Title:
Realignment of Air Suspension Pressure Sensor

Applies To:
Prostars with Advance Brake Systems

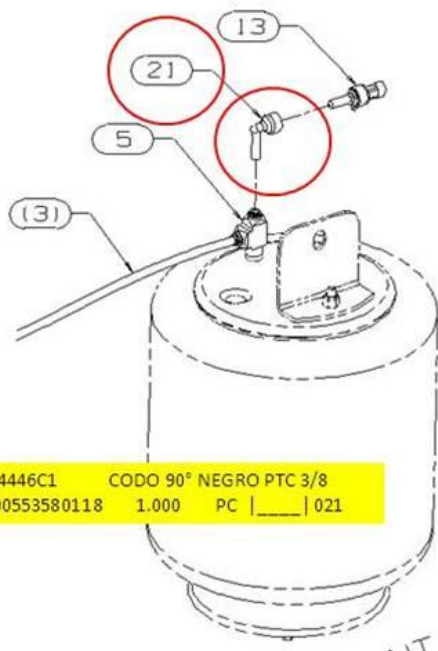
The Air Pressure Sensor may be mounted vertical and needs to be mounted horizontal.

1. Examine the sensor mounting at the left rear air suspension to see if it is mounted vertically.

Remove pressure sensor from vertical mounting. Correct seal placement if needed and clean or replace terminals as required. Obtain item 21 below (2024446C1 - Elbow Quick Connect 3/8" Tube X 3/8" Stem) and install as recommended. Install sensor into added elbow and reattach to harness and secure wiring.
